Please find below the response to the Request for Review for the CDM project “Gansu Datonghe Tiecheng Hydropower Station Project“ with UNFCCC project number 2108. In case you have any further inquiries please do not hesitate to contact us.

## Response to the CDM Executive Board

**Figure 1 Results of the sensitivity analysis – operational lifetime 20 years.**

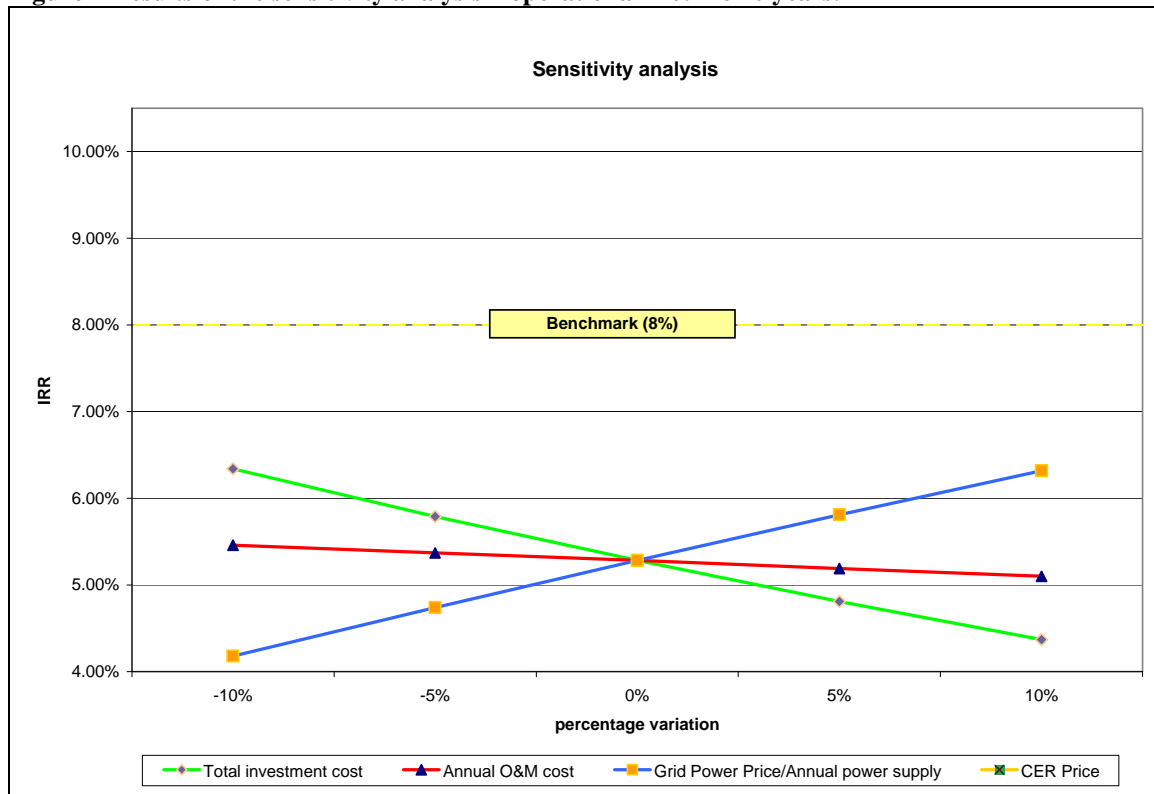
***The PP/DOE are requested to clarify: a) the difference between the O&M costs, bank loan financing and interest and IRR results stated in the PDD and Validation Report and the ones used in the spreadsheet provided and; b) the appropriateness of the period of analysis applied in the investment analysis compared to the operational lifetime of the project.***

The IRR for a construction period of 4 years and operational period of 20 years can be calculated as 5.28% without CER revenues and 8.78% with CER revenues. As the relevant benchmark for the proposed project activity has been identified as 8% the conclusions with regard to additionality remain unchanged. These results also hold in case +/-10% variations in the main input parameters are applied as indicated in Table 1 and graphically displayed in Figure 1.

Regarding issue b), as project participants mentioned in above discussion that for this specific project an extended operational lifetime is more conservative in the CDM context.

For better understanding of the investment analysis, calculation of the Internal Rate of Return for both 20 year period and 30 year period in addition to the 26 year period has been provided. It is clear that the Internal Rate of Return is lower than the applied benchmark 8% in all cases (IRR without CER revenues reaches in case of 20 years lifetime 5.25% and 6.80% when assuming 30 years lifetime). In all cases the additionality criterion is met. Further it is a more conservative approach to apply the longer lifetime of 30 years, as now presented in the revised IRR spreadsheet.
